Rev	Date	AMENDMENT
A	23.01.18	Updated to Manufacture Issue; Duplex Rod size now 750mm; Duplex Handle height dims off vent and intermediate transom amended and added respectively; Notes added, omitted and amended as per revision clouds.

PROJECT
DANTZIC BUILDING
Dantzic Street, Manchester. M4 4DE

Drawing Title
Elevation & Section Details
Window W4.26
ATRIUM Elevation. (**Level 4 / 1st Flr**)

DRAWING No.
3072 - 14
REVISION A

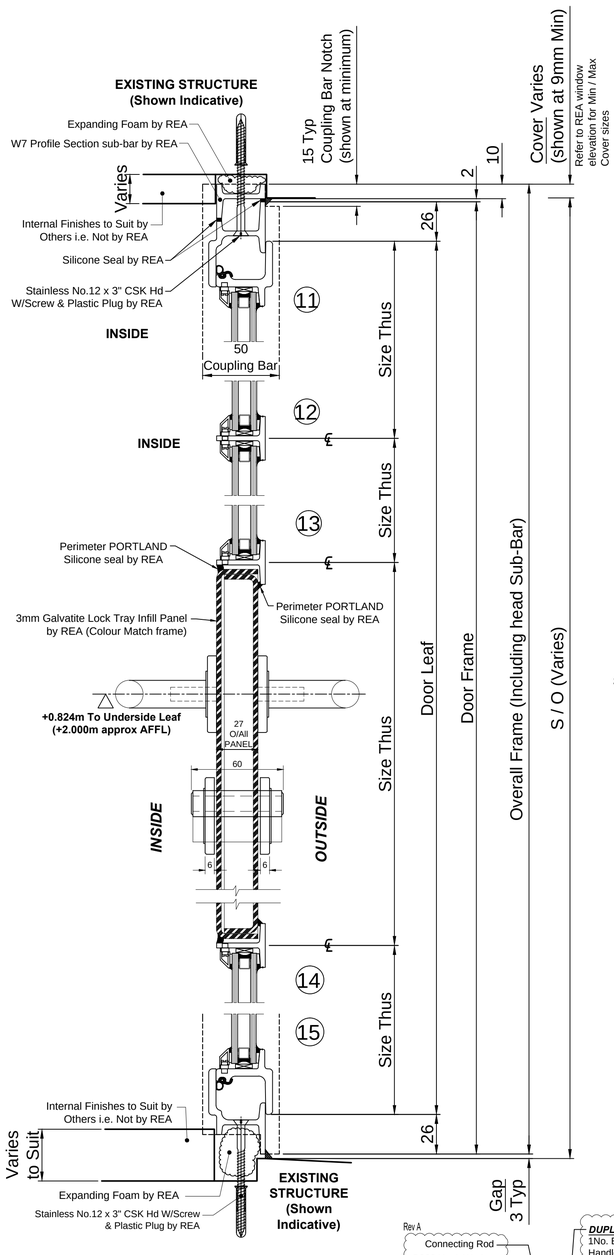
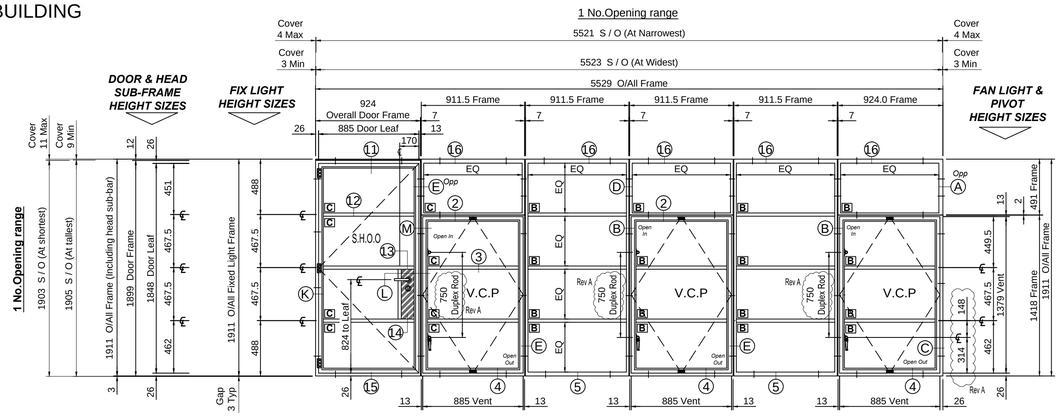
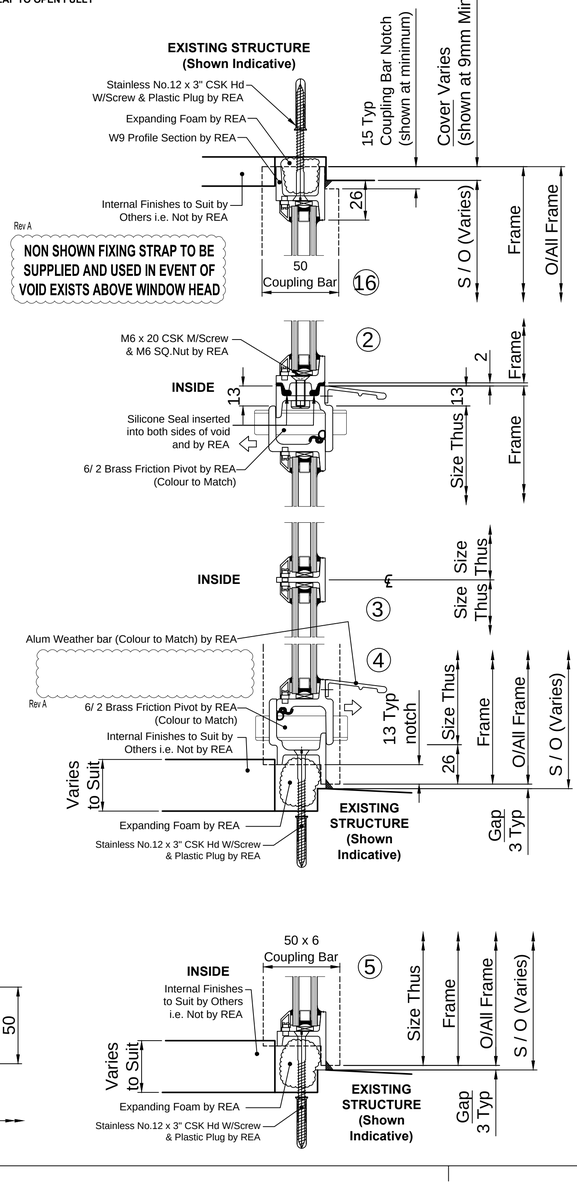
DOOR LEVER HANDLE SHOWN 2000mm APPROX ABOVE EXISTING INTERNAL FLOOR LEVEL. THE HANDLE POSITION IS BASED SOLELY ON THE ASSUMPTION TO OPEN THE ACCESS DOOR WILL REQUIRE THE OCCUPANT TO STEP ONTO THE SUITABLE INTERNAL SILL BOARD TO OPERATE DOOR HANDLE

DOOR LEAF SIZE SHOWN WILL FOUL THE EXTERNAL RWDP TO ADJACENT WALL, LOCATED 700mm APPROX FROM EXISTING WINDOW FACE ON PLAN, PREVENTING DOOR LEAF TO OPEN FULLY
